From: Dearnell, Lori
Sent: Friday, May 03, 2013 2:07 PM
To: jrheppner@aep.com; tlhairston@aep.com; Buskirk, Doug (Doug.Buskirk@dot.state.oh.us); Pack, Doug (Doug.Pack@dot.state.oh.us); Steven.Pennington@dot.state.oh.us
Cc: Hyre, Brad; Dearnell, Lori
Subject: SCI-823-0.00: AEP Transmission Line Crossings

The SR 823 Portsmouth Bypass project has been ongoing for many years now and will soon be transitioning to alternative delivery. HDR is wrapping up involvement with the project and this email is to summarize previous correspondence and the current design regarding your facilities.

I have attached three email chains regarding the AEP transmission line crossings of the proposed SR 823 Portsmouth Bypass project. The first correspondence was with John Cookman in response to the PAVR submittal in 2005, while the second and third correspondence was with John Heppner and Dan Woeste in order to verify clearances with the Stage 1 design.

PROFILE - SR823
STA. 202+00 TO STA. 214+50

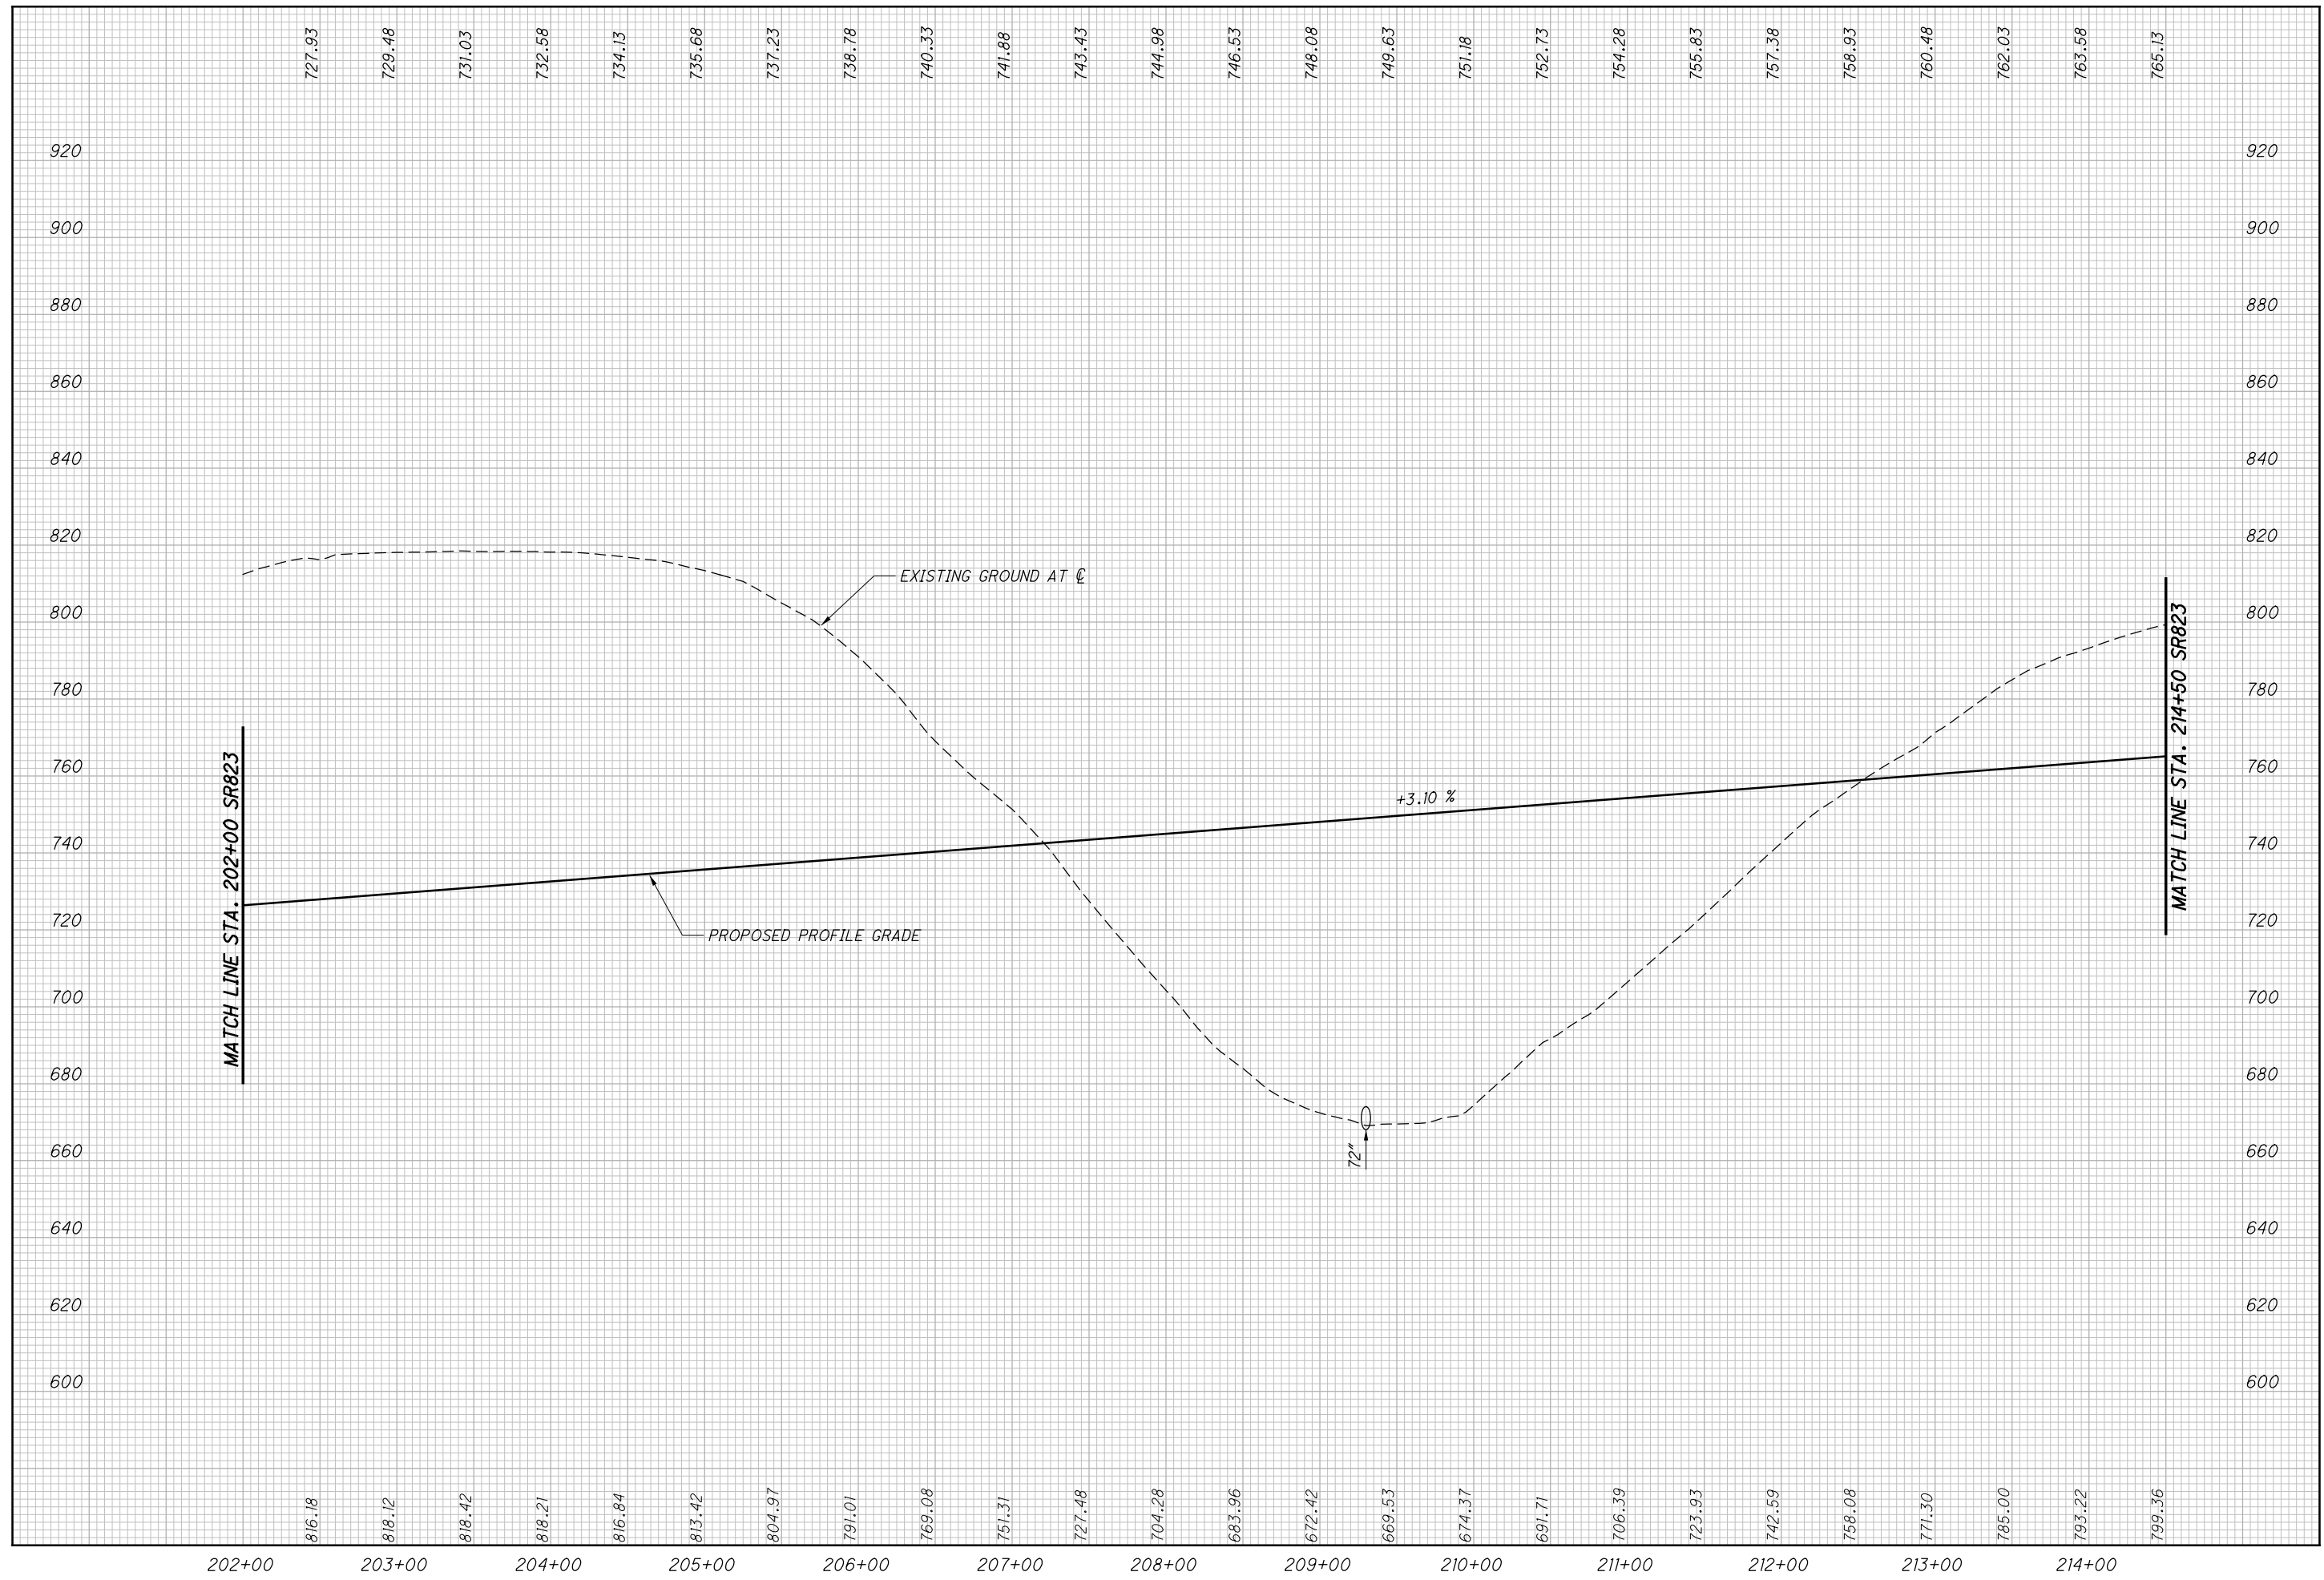
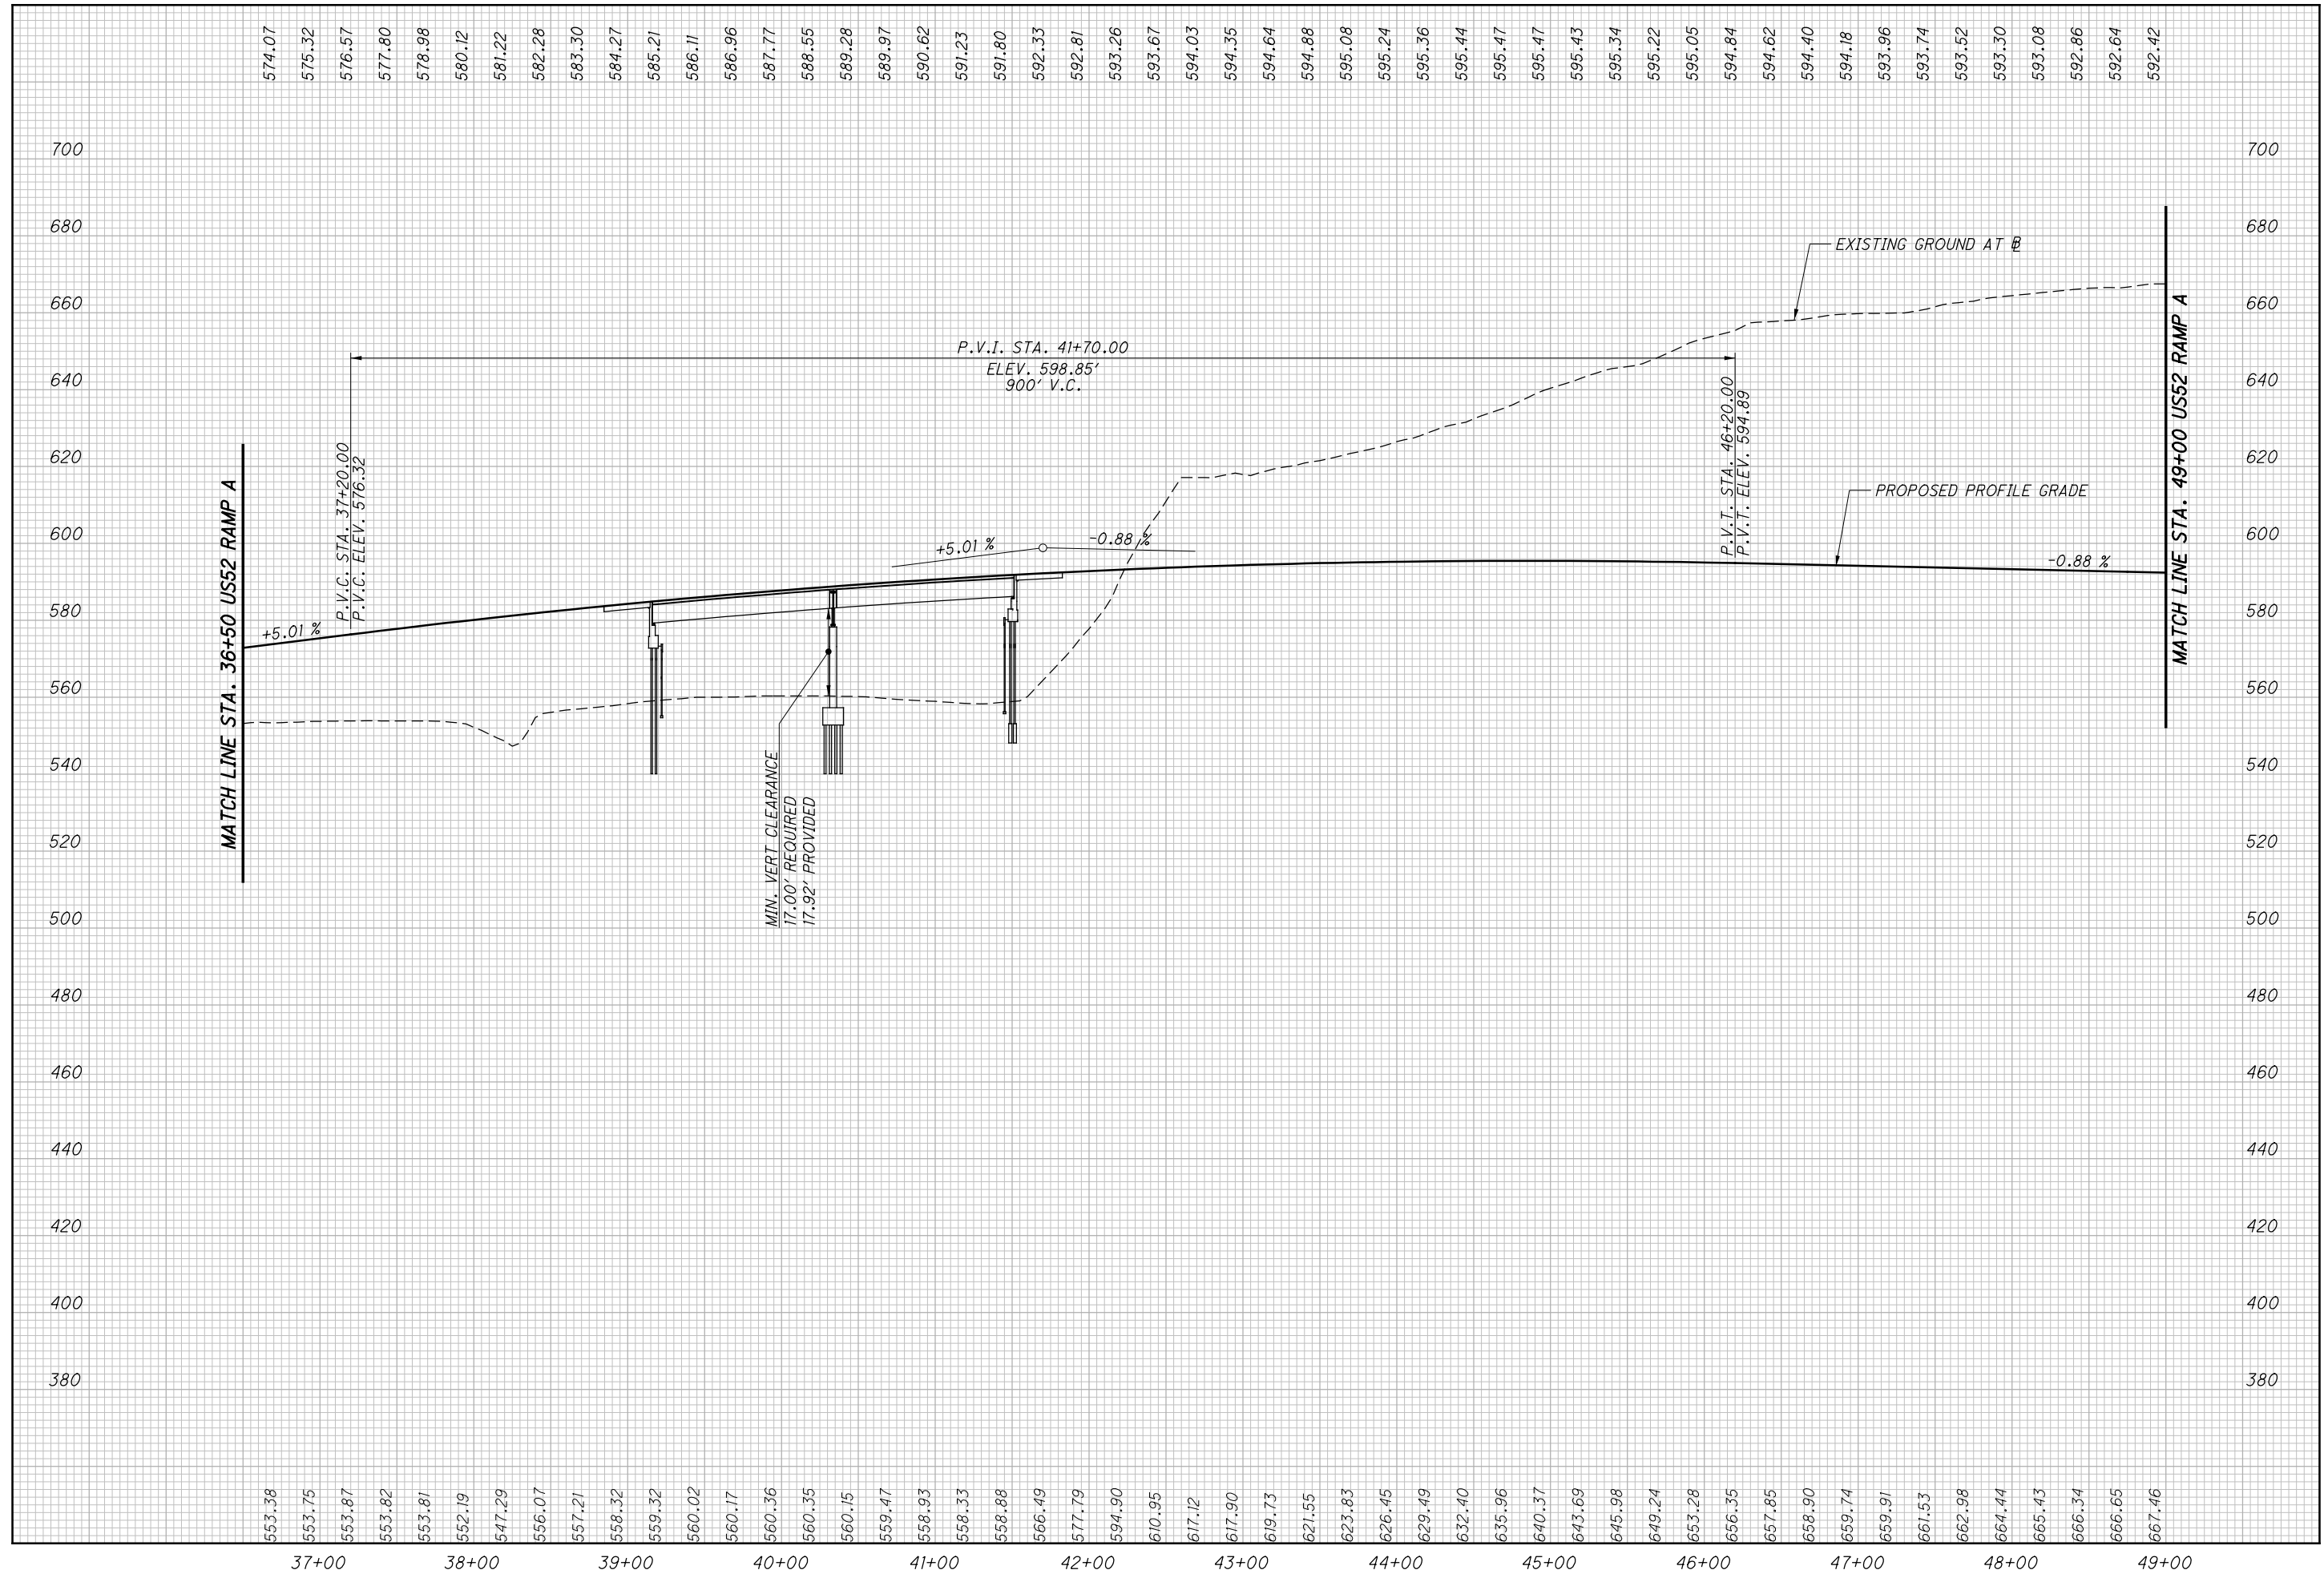
The fourth crossing is the Baker Don Marquis 765kv line between structures 73 and 74. At the crossing location, plans indicate approximately 50' of fill. According to record information, the clearance for the existing line above the proposed roadway would be reduced to 65'. This is a definite concern. Per AEP TLES10 guidelines, Electrostatic Clearance required for 765kv above 2 and 3 land public roads is 66'. This clearance is based on a vehicle height of 14'.

This crossing will need a complete on site analysis. My concern is the large dump trucks used in this types of fill operation and the possibility of a truck passing under the line with the bed in the "dump position".

In summary, AEP's major concern is the Baker Don Marquis 765kv line and the reduction of clearance at highway station 207+50. I do not have the electronic file so my measurements were based on scaled distances from the plans you

provided. This area needs detailed study to insure proper clearance above the entire width of the road. The cost and time constraints for even a minor adjustment to a 765kV structure are enormous. Please consider AEP's request for additional study and centerline adjustment at this station if required.

After briefly reviewing the elevations on the only profile drawing that we received (sta. 202+00 to sta. 214+50) and cross checking it to the clearance that is required, it appears that this particular span will most likely meet clearance. I would like for you to confirm this as I was only able to interpret the location of the proposed roadway based on the topography of the span.
